GROUND FLOOR DETAILS

LISTED BUILDING CONSENT				 kyson			
Rev:	Comments:	By:	Date:	Client:	Studio		
B	Amendments as clouded-reinstatement of the historic staircase	KN	Nov 25	Mr. Simon Dougall	28 Scrutton Street London UK EC2A 4RP		
C	First floor stair access door reinstated	KN	Feb 26	Project Title:	T: +44(0) 20 7247 2462 E: enquiries@kyson.co.uk W: www.kyson.co.uk		
				107 High St, Lindfield, Haywards Heath, West Sussex, RH16 2HR			
				Drawing Title:			
				Detail Drawings:			
				Corkscrew Winder Staircase - Ground Floor			
				Scale:	Date:	Drawn:	Checked:
				1:25@A1 1:5@A1	Apr 25	KN	KW
				1:50@A3 1:10@A3			
Do not scale this drawing All dimensions must be checked on site. All rights reserved. No reproduction in any material form is permitted without consent.					Project No.:	Drawing No.:	Revision:
					900-25	5007	C

Section AA
Scale 1:25@A1
1:50@A3

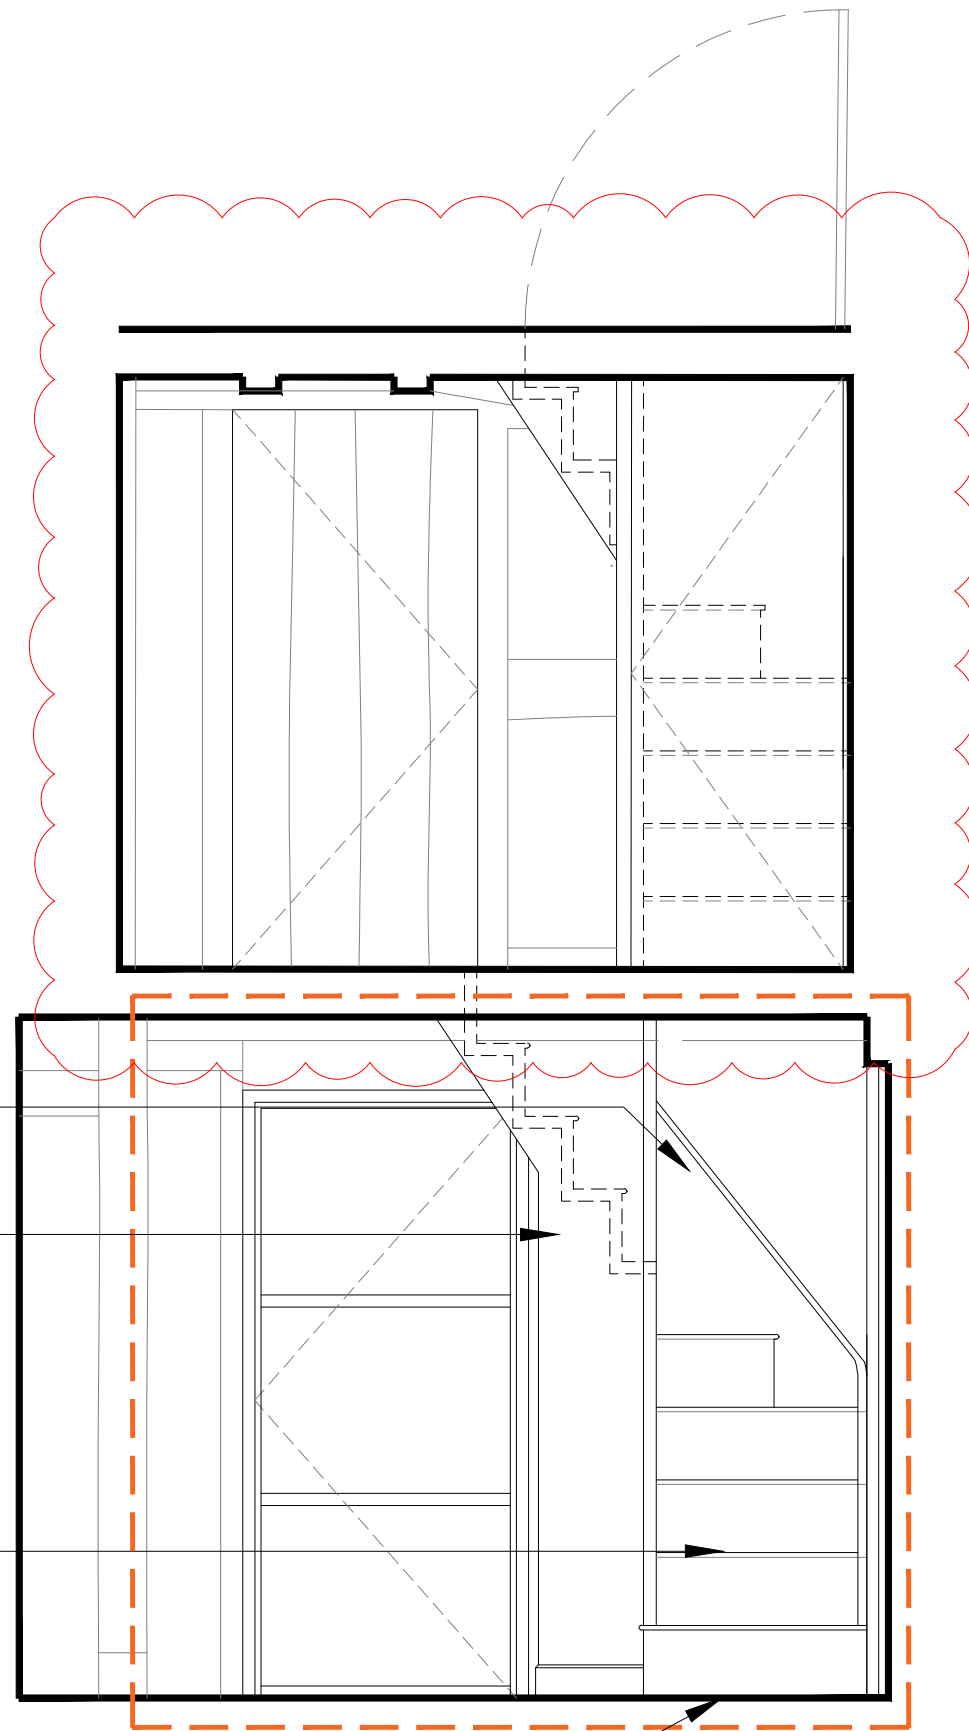
- Reinstated stringer
- As-built side window to be removed and filled in
- Timber staircase encasement and basement access door reinstated
- Historic timber staircase to be reinstated.
- Existing access hatch to basement removed.

Detail 01 - Steps
Section
Scale 1:5@A1
1:10@A3

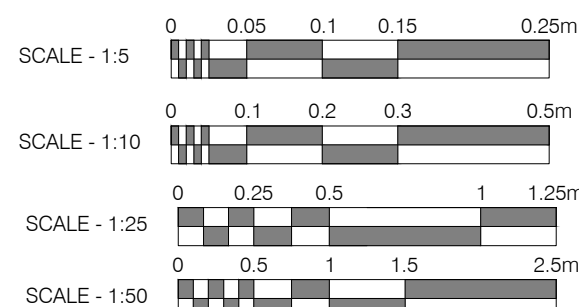
Steps constructed of salvaged timber attached to the string

Reflected Ceiling Plan
Scale 1:25@A1
1:50@A3

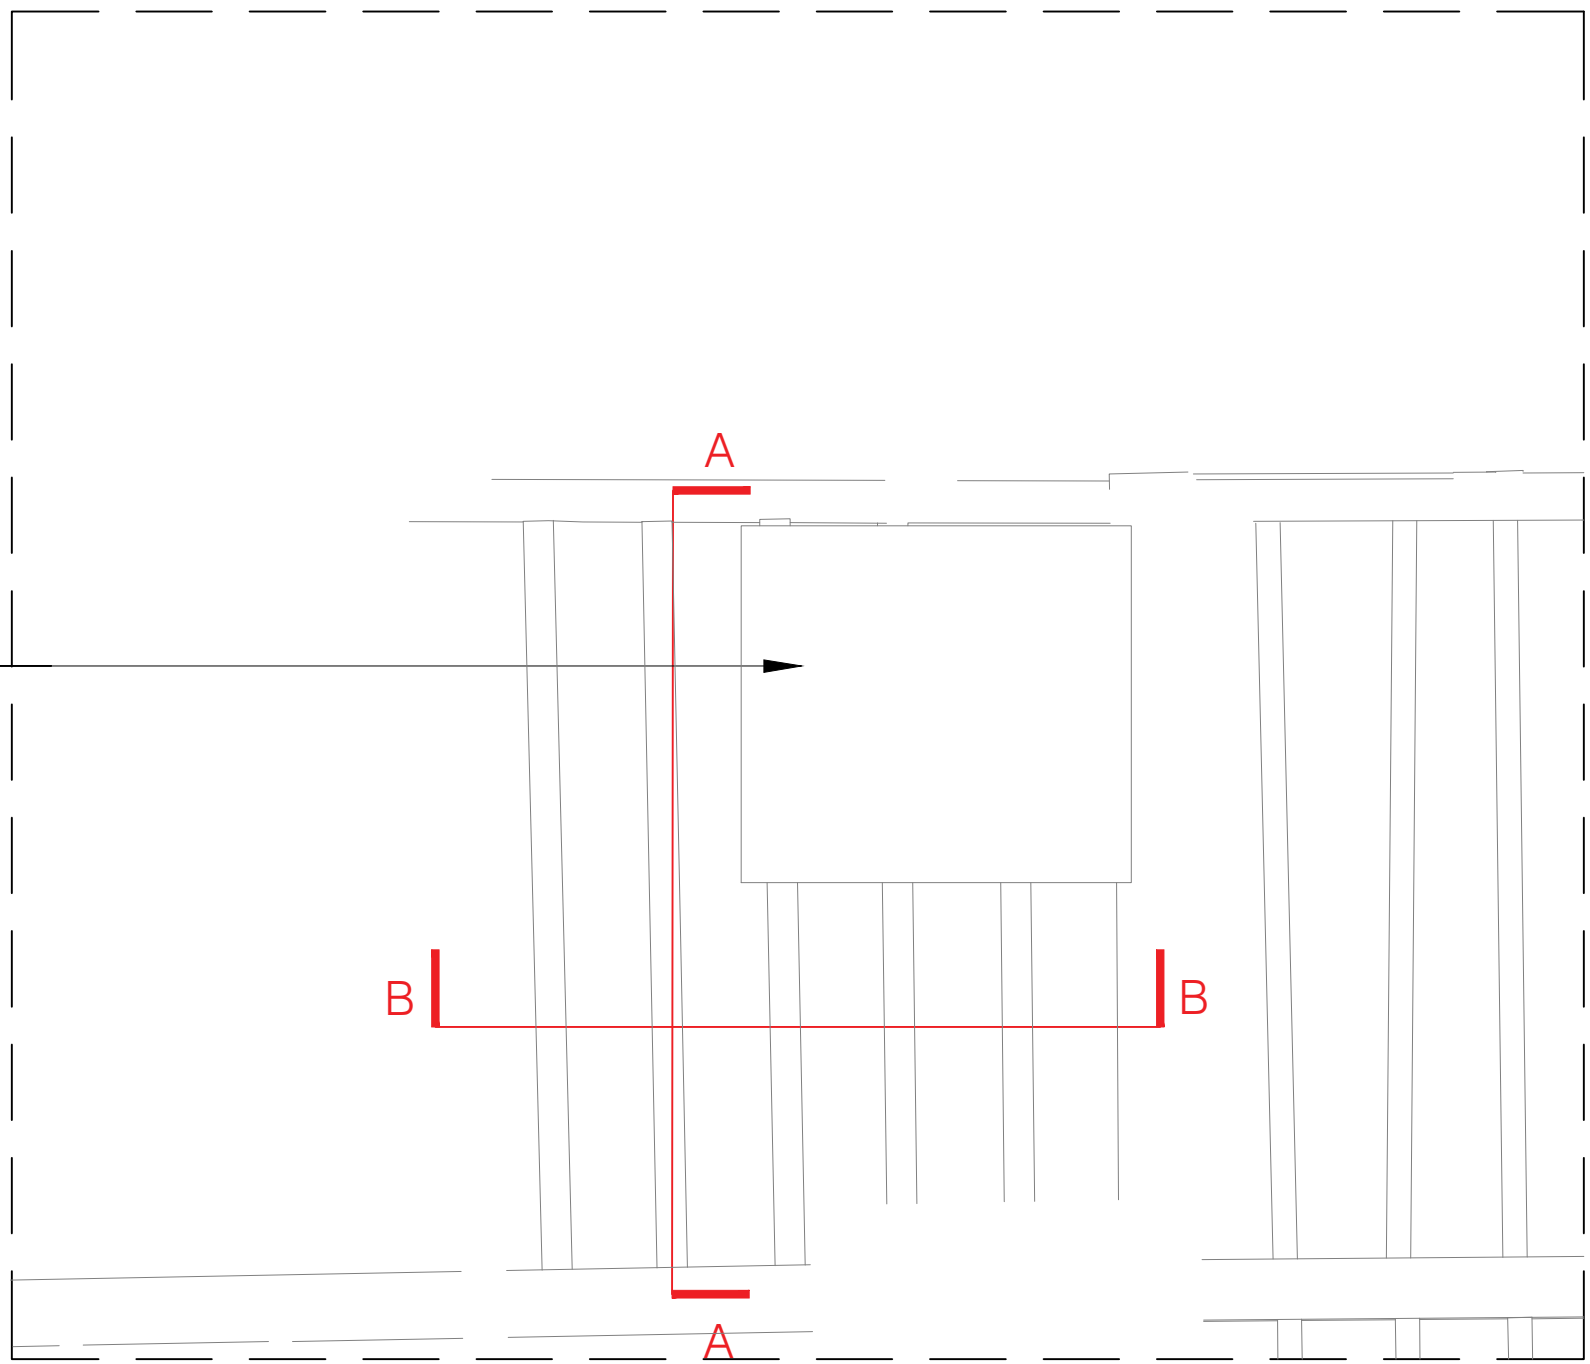
Not original timber joists removed,
historic opening in the ceiling reinstated

Ground Floor Plan
Scale 1:25@A1
1:50@A3

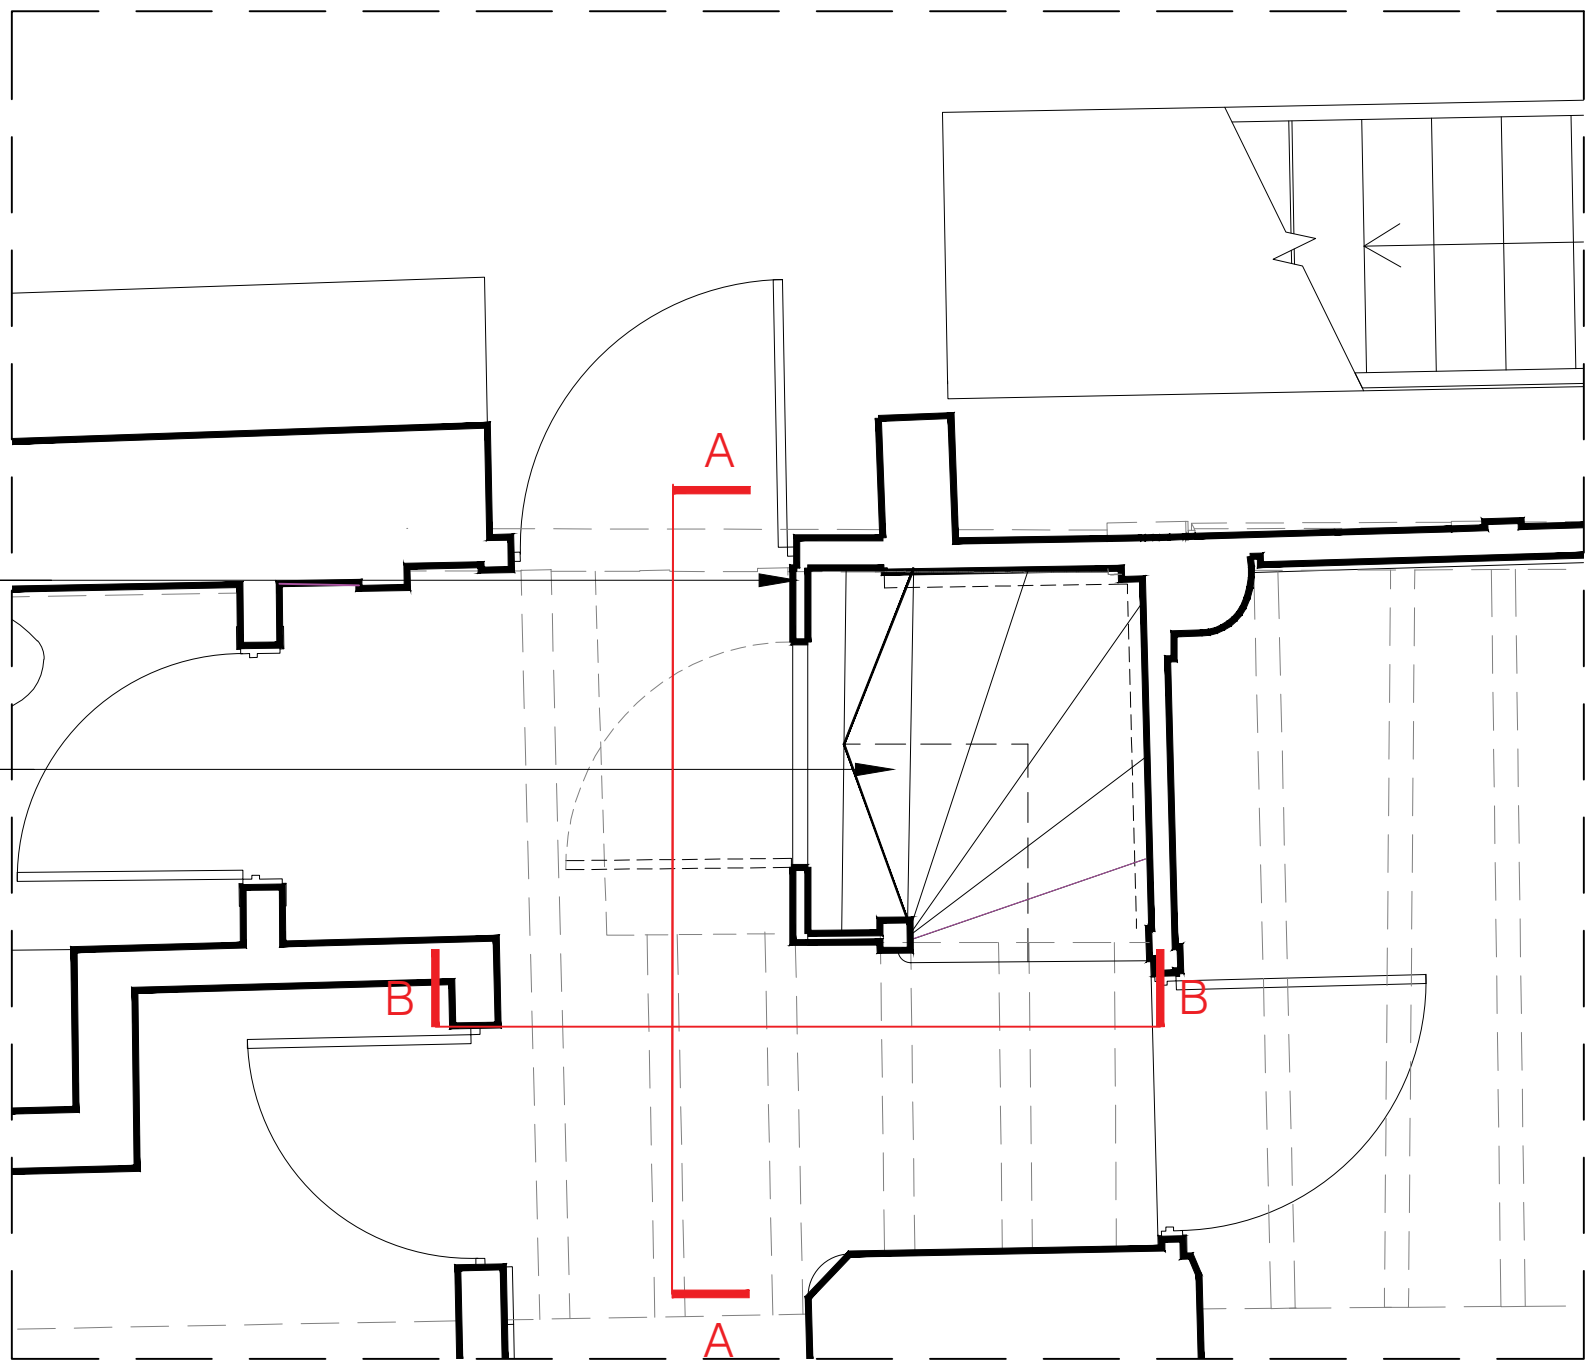
Existing basement access hatch to be removed. Timber staircase enclosure with timber basement access door to be reinstated
Historic timber staircase reinstated, new timber steps to replicate the original.
